**The Arcade, Dewsbury
& 18-20 Corporation Street / 17 Foundry Street**

Design and Heritage Statement Addendum

1705-BDP-AD-XX-RG-Z-00006

DRAWING TITLE
Elevations as Proposed

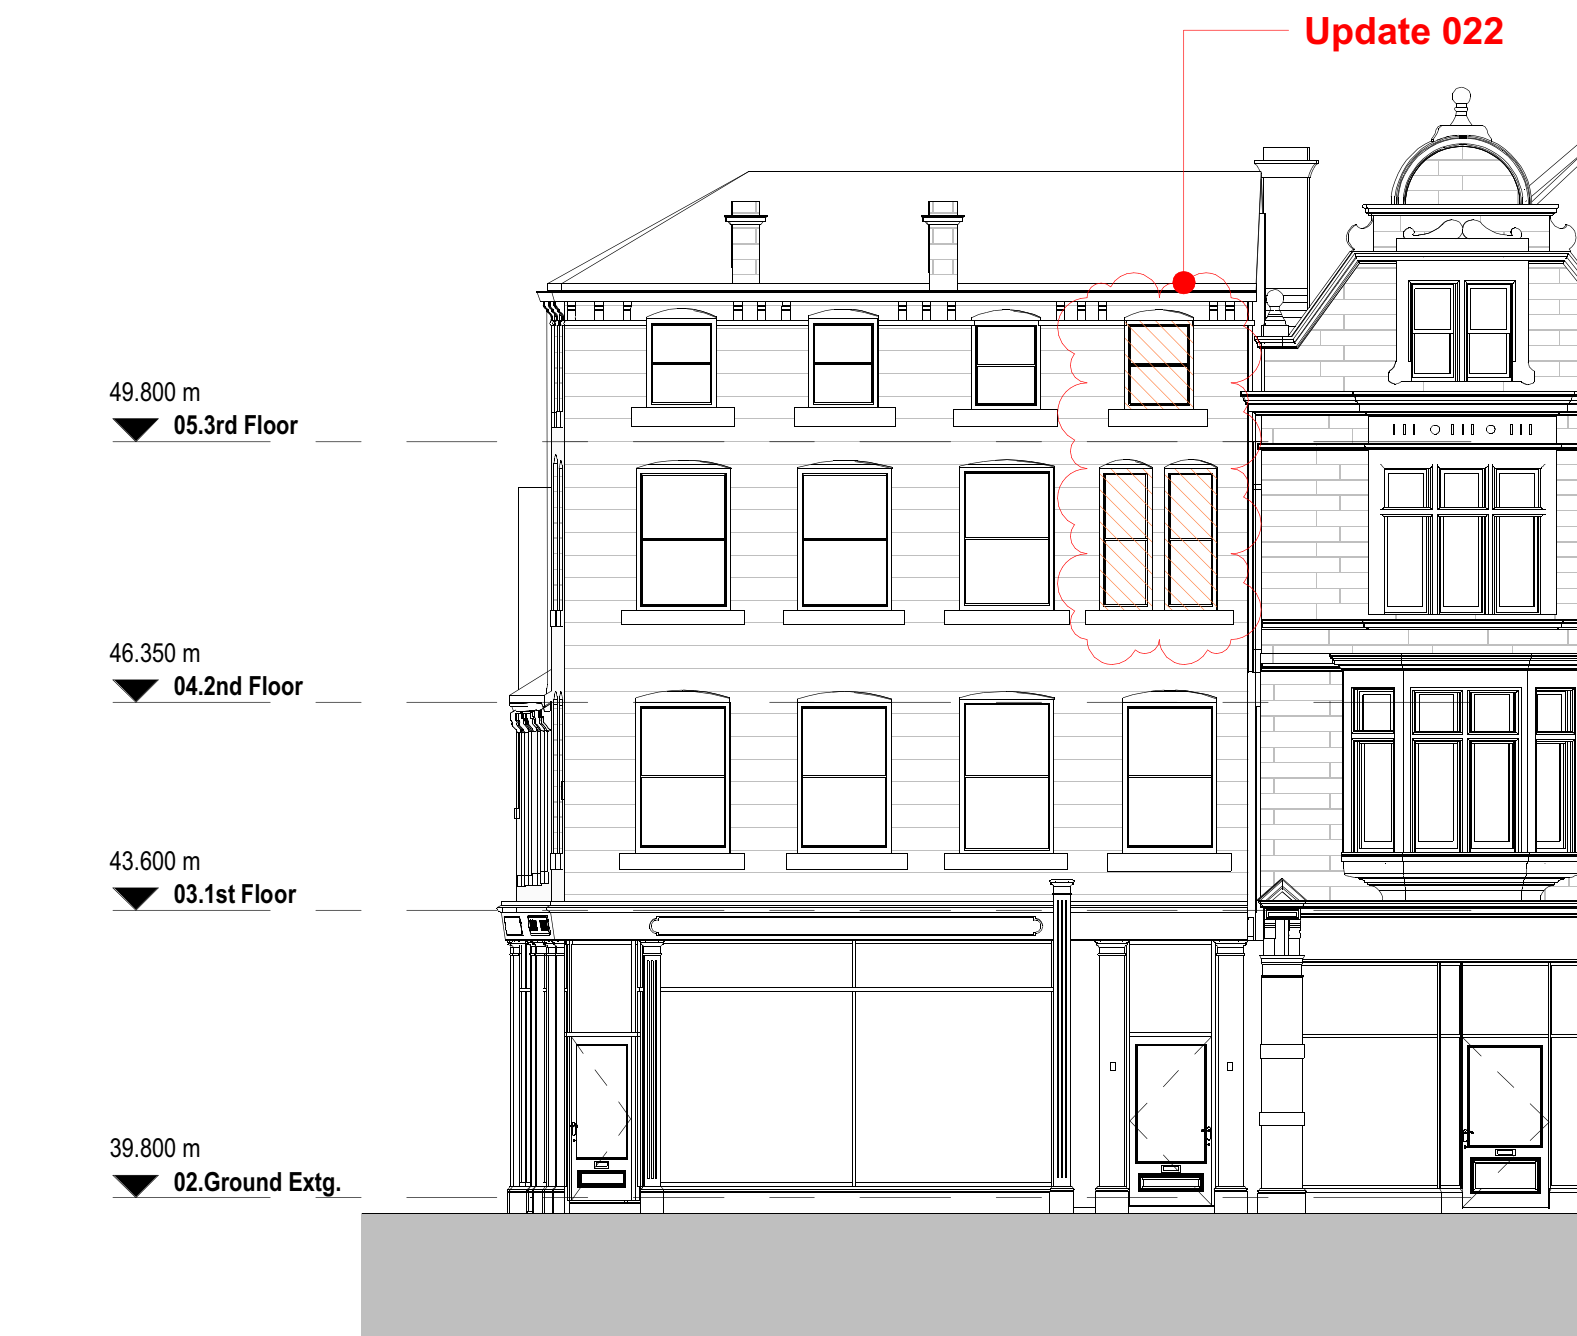
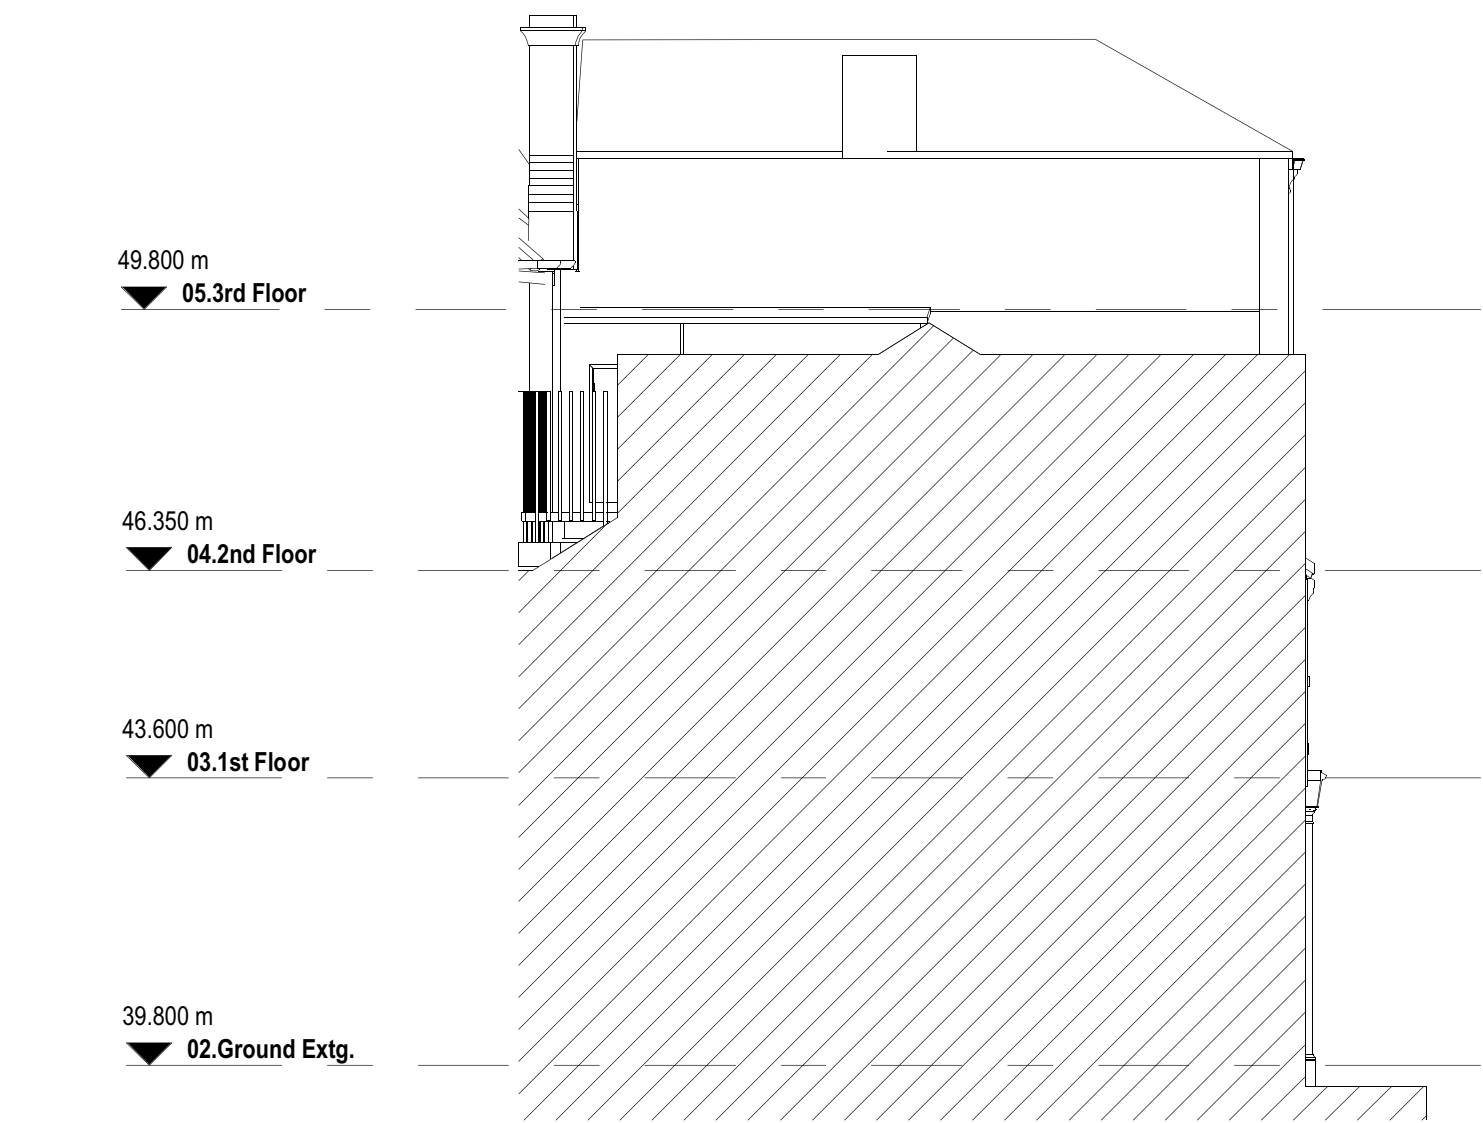
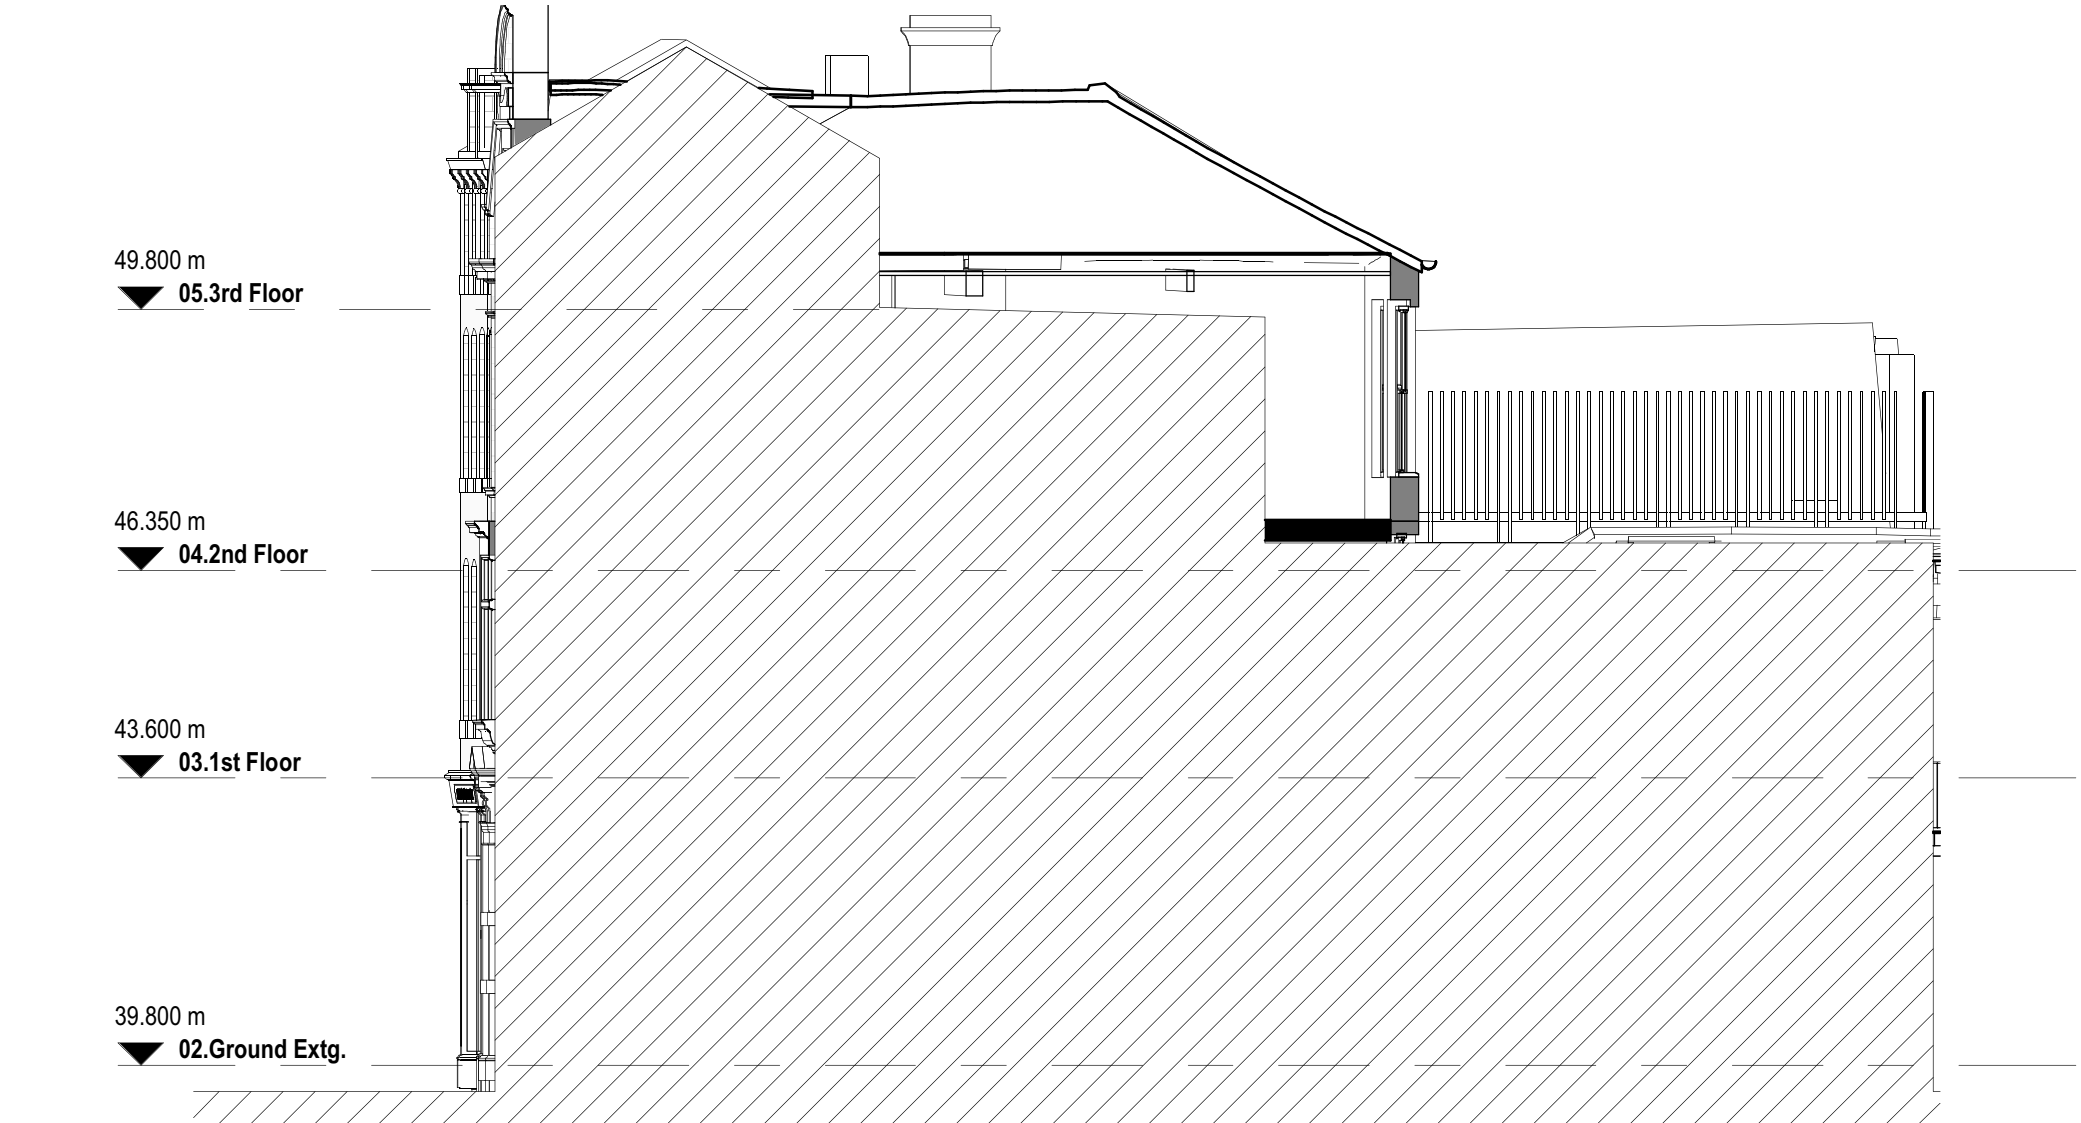
022	Central Arcade, 14-16 Corporation Street and 18-20 Corporation Street Refer to elevation drawings	Windows	Repair windows where possible using traditional techniques. Some windows were known to have extensive wet or dry rot, or were absent and were therefore proposed to be replaced.	Additional windows were found to have extensive wet and dry rot. (2 to 14 Corporation Street North Elevation, 2 to Central Arcade East Elevation, and 2 to Central Arcade West Elevation, 3 to 18-20 Corporation Street North Elevation)	CONDITION: These additional windows are so extensively decayed to the extent that they are in very bad condition and unsuitable for repair.	Replace 6 no. windows, in addition to the 3 no. already proposed to be replaced (in unit 30, shown on Section AA). Replacement windows to match existing in size, proportions and timber profiles.	Negligible	1705-BDP-AD-XX-EL-A-20001_P01 1705-BDP-AD-XX-EL-A-20005_T01 1705-BDP-AD-XX-EL-A-20004_P01 1705-BDP-AD-XX-SE-A-20002_P01 1705-BDP-18-ZZ-EL-A-00002_P04	1705-BDP-AD-XX-EL-A-20001_T02 1705-BDP-AD-XX-EL-A-20003_T02 1705-BDP-AD-XX-EL-A-20004_T02 1705-BDP-AD-XX-SE-A-20002_T02 1705-BDP-18-ZZ-EL-A-00002_P05
